Subject: VAREZE RESIDENTIAL PROJECT

MINOR MODIFICATIONS TO APPROVED PLANS

RE: Vareze Residential Project by Quadrant Homes

BUILDING A ELEVATIONS

Right Elevation Revisions:

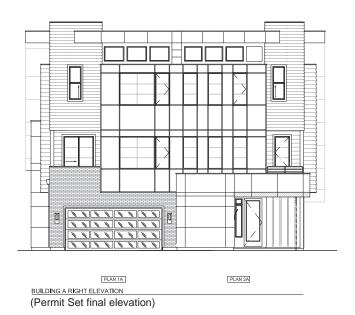
Unit 1A: The roof deck has been removed. Transom windows have been added to the third floor. Unit 2A: The roof deck has been removed. Transom windows have been added to the third floor. Also, the exterior material next to the entry door has been changed to smooth panel with battens.

Left Elevation Revisions:

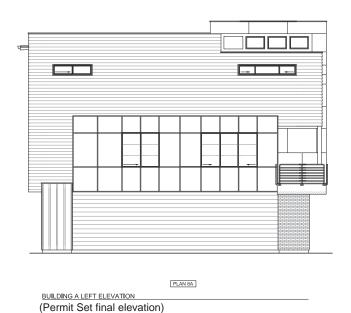
Unit 8A: A transom window has been removed from the third floor. The exterior elevation material on the first floor (left side) is now smooth panel with battens.
